<b>Model:</b> PRIPORT PEARL		<b>Date:</b> 31-Dec-98	<b>No:</b> 01
<b>Subject:</b> Pressure Cylinder Maintenance Cycle		<b>Prepared by:</b> H. Kokubo,  Priport Service Planning Section	
<b>Classification:</b>	<input type="checkbox"/> Troubleshooting <input type="checkbox"/> Mechanical <input type="checkbox"/> Paper path <input type="checkbox"/> Other (      )	<input type="checkbox"/> Part information <input type="checkbox"/> Electrical <input type="checkbox"/> Transmit/receive	<input type="checkbox"/> Action required <input checked="" type="checkbox"/> Service manual revision <input type="checkbox"/> Retrofit information
<b>Model Name:</b> PEARL: Ricoh JP5000, Gestetner 5450, RexRotary 1560, nashuatec CP450, SVN 3350DNP

<b>Model:</b> PRIPORT PEARL		<b>Date:</b> 31-Dec-98	<b>No:</b> 02
<b>Subject:</b> Master Feed Jams or Cutter Errors		<b>Prepared by:</b> H. Kokubo, Priport Service Planning Section	
<b>Classification:</b>	<input checked="" type="checkbox"/> Troubleshooting <input type="checkbox"/> Mechanical <input type="checkbox"/> Paper path <input type="checkbox"/> Other (      )	<input checked="" type="checkbox"/> Part information <input type="checkbox"/> Electrical <input type=

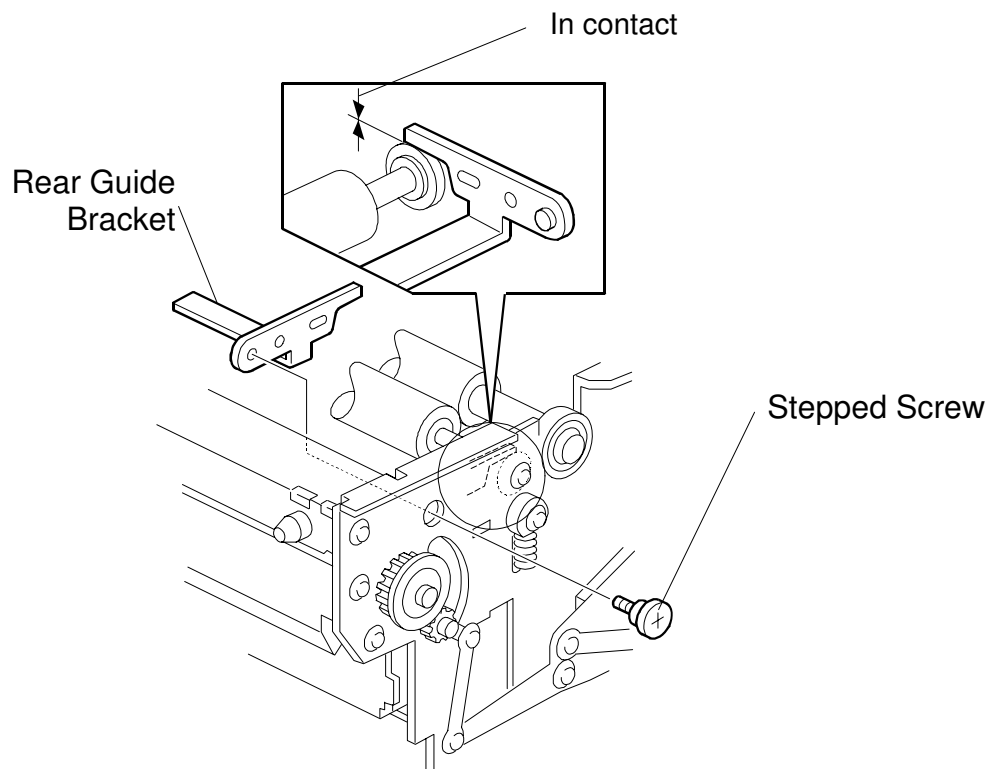
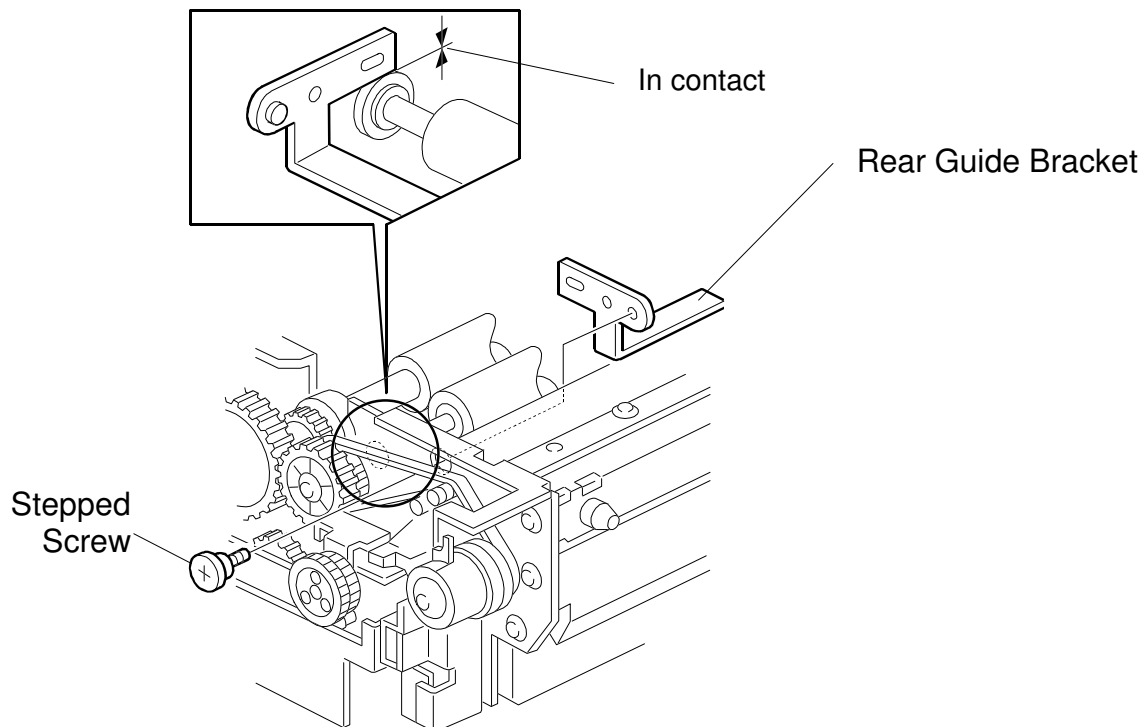
To ensure that the master is guided into the buffer duct, the following parts have been registered as service parts.

- **Anti-static Brush - 310: C229 2071**
- **Master Guide Kit: C230 2175**

- NOTE:**
- 1) We recommend that you install these two parts at the same time for the best effect.
  - 2) The kit (#C2302175) contains the front guide bracket (#C2302176), rear guide bracket (#C2302177), and two stepped screws (2 x #C2302178).
  - 3) These parts were implemented into production from December 1998.

1. Remove the cutter unit. (For the removal procedure, refer to the service manual.)

2. Install the front guide bracket (in the operation side of the unit) using the stepped screw, as shown above.

3. Install the rear guide bracket (in the non-operation side of the unit) using the stepped screw, as shown above.

**CAUTION:** 1) The two brackets are different. Make sure to install them in the correct positions by referring to the diagrams above.  
 2) Make sure that both brackets are in contact with the flanges of the ball bearings at each end of the roller. (See diagram.)

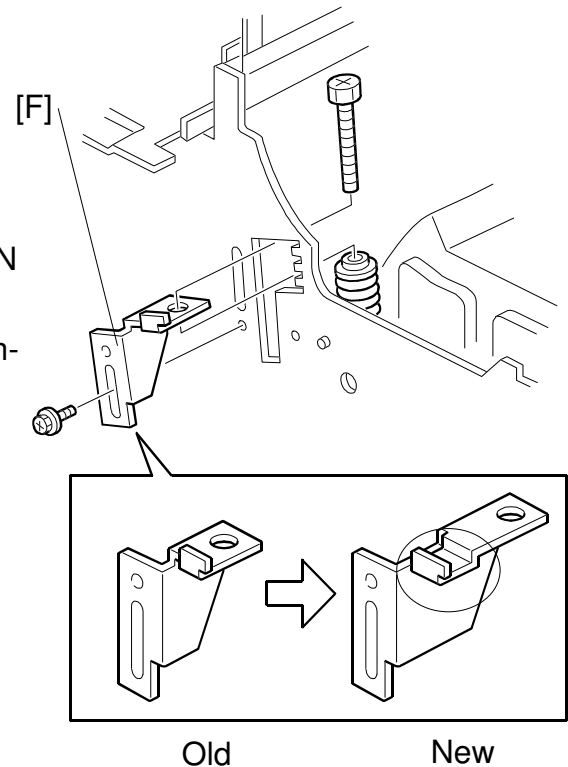
4. Remove the front spring bracket [F] (1 bolt and screw), and install the new front spring bracket (P/N C2293275).
5. Similarly, replace the rear spring bracket at the non-operation side. (P/N C2293276)

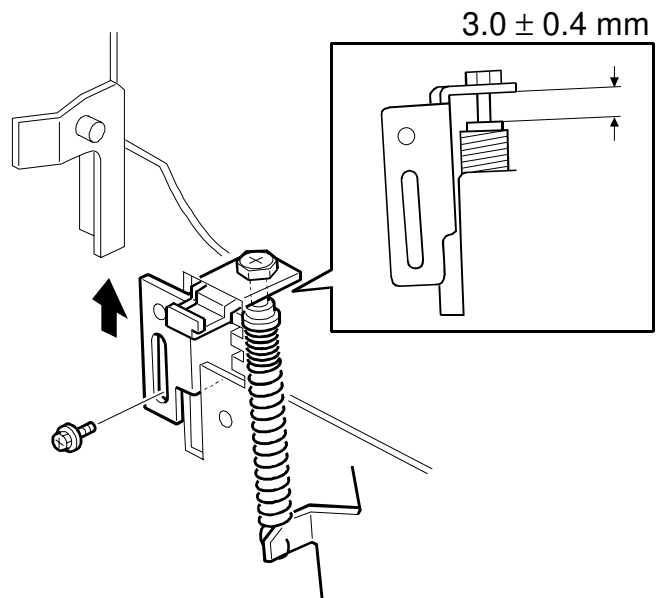
**NOTE:** 1) Steps 4 and 5 are required only when you want to install the new brackets.  
 2) The printing pressure can be increased (up to 16 kgf) even without replacing the brackets.

6. At the operation side, adjust the clearance to  $3.0 \pm 0.4$  mm by turning the bolt.
7. Repeat the same procedure on the non-operation side.

## - Adjustment standards for new and old spring brackets -

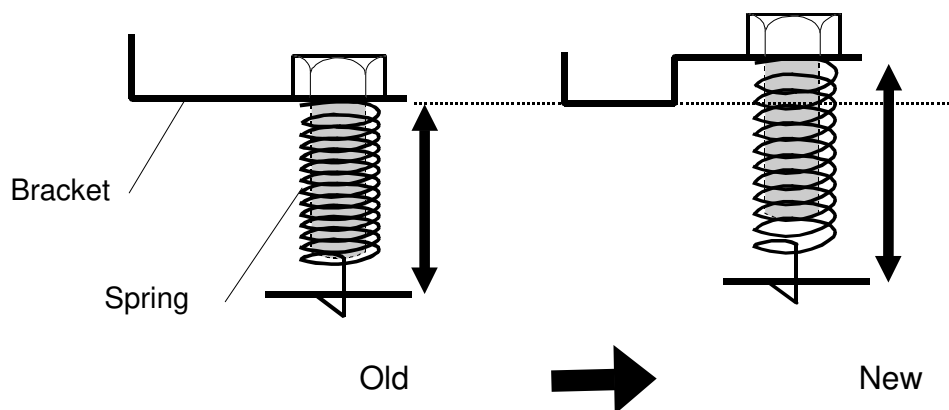
The configurations of the old and new spring brackets as well as the adjustment standard have been changed.

If you do not replace the spring brackets with the new type, set the adjustment value to 0 mm, which means to fully tighten the bolts.

## SYMPTOM

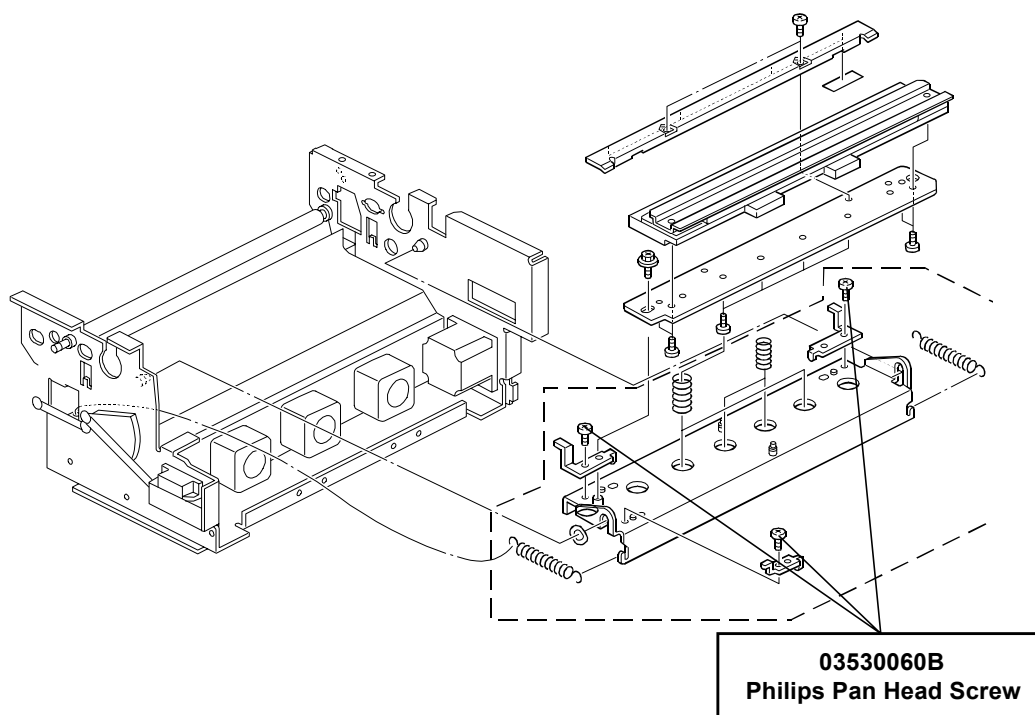
In some machines, the shape of the 3 screws under the thermal head is different from the standard ones used in the Plotter Unit, causing solid image areas to appear light.

## Cause

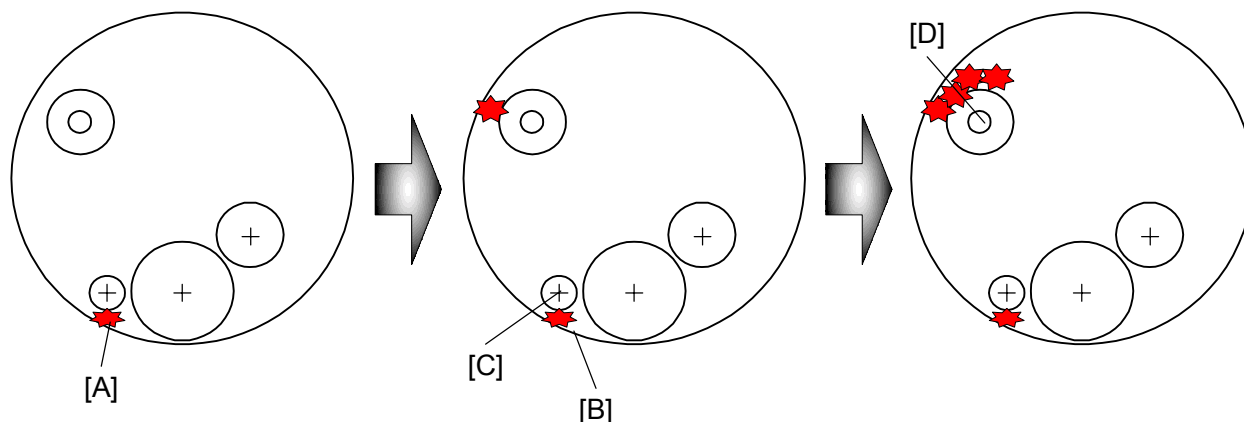
Producing over 2,000 prints with the same master causes an ink buildup to occur [A] between the inner surface of the drum metal screen [B] and the drum idling roller [C], after which the buildup is transferred to the area of the ink pump motor [D].

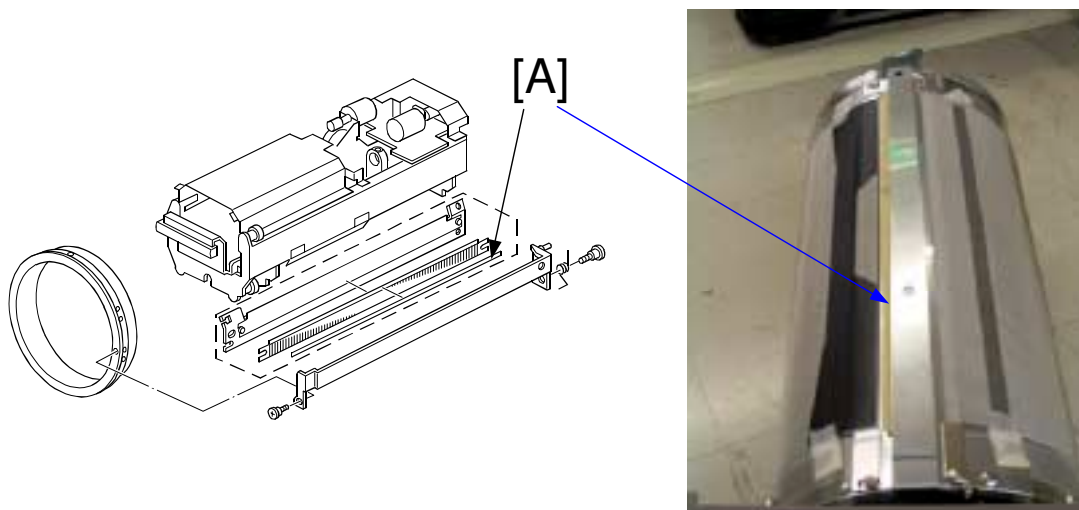
The color of the sandpaper [A] on the clumper base was changed back to similar to its original color from August 2004.
